RE: UACCM Library Construction Site

NPDES Permit No.: ARR150000 - NPDES general construction stormwater discharge permit

# NPDES Compliance Inspection Report

Water Division Construction Storm Water Photographic Evidence Sheet									
---	--	--	--	--	--	--	--	--	--

<b>Photo #</b>	1	<b>Of</b>	4	<b>Date:</b>	9/17/08	<b>Time:</b>	0911		
----------------	---	-----------	---	--------------	---------	--------------	------	--	--

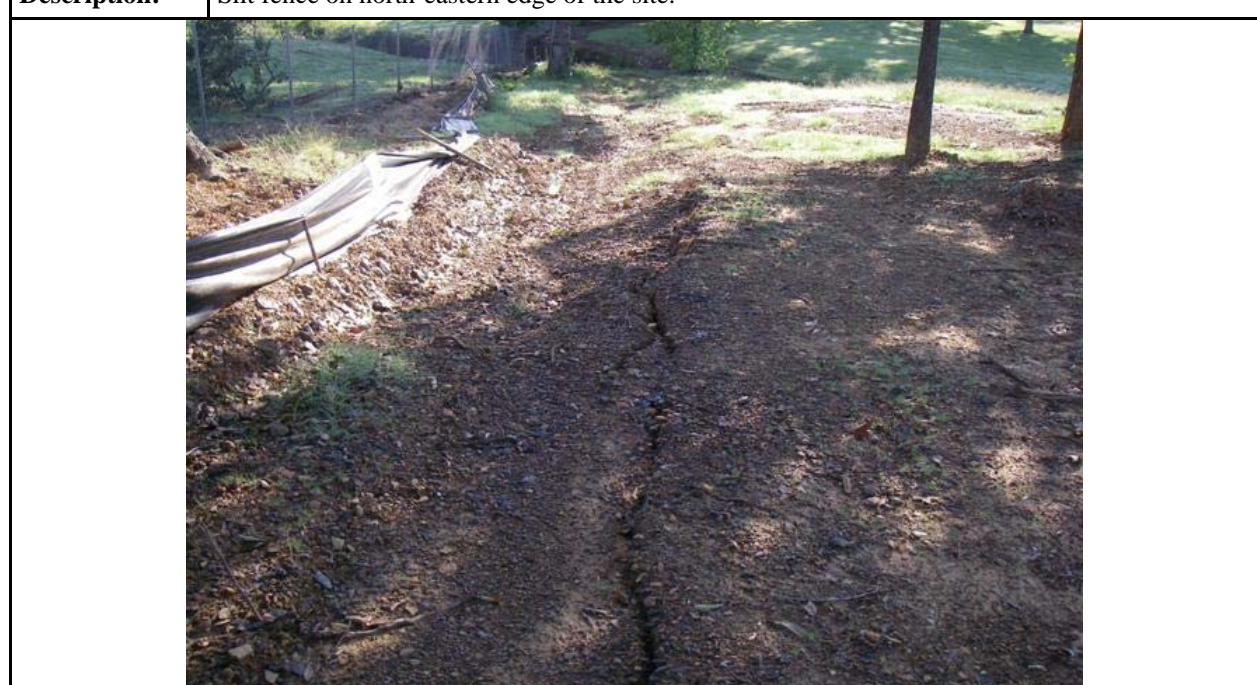
4. **Silt fences on the site have not been maintained and are ineffective in their current condition. This is a violation of your permit as stated in Part II, Section A, condition 4.b.**

<b>Description:</b>	Silt fence on northern edge of the site.								
---------------------	--	--	--	--	--	--	--	--	--

- All sediment onsite is, and will be contained with the use of silt fences and/or hay bails.
- The project storm water pollution prevention plan is filed on the jobsite mailbox along with the construction site notice.
- All silt fences have been either repaired or new fences erected in their place. These fences will be inspected daily for the duration of the project, and repaired as required.
- Rainfall at the site will be monitored and logged daily, and be filed in the jobsite mailbox.
- GAG will inform subcontractors that no construction materials or should make their way into the creek.
- The attached construction notice will be posted on site in the GAG job trailer.

<b>Photo #</b>	4	<b>Of</b>	4		<b>Date:</b>	09/17/08	<b>Time:</b>	0916
----------------	---	-----------	---	--	--------------	----------	--------------	------

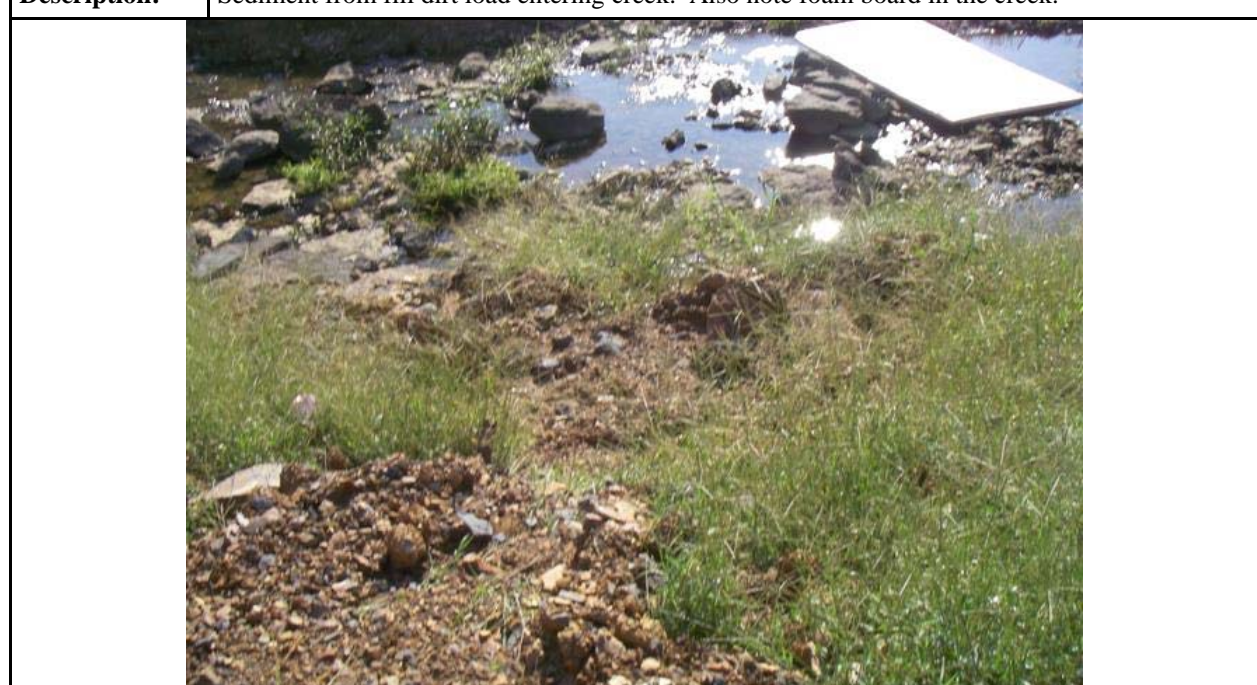
1. **Sediment from the site is entering an unnamed tributary of Point Remove Creek causing pollution to waters of the state. This is a violation of the Arkansas Water and Air Pollution Control Act Section 8-4-217(a) (2).**

<b>Description:</b>	Sediment from fill dirt load entering creek. Also note foam board in the creek.							
---------------------	---	--	--	--	--	--	--	--
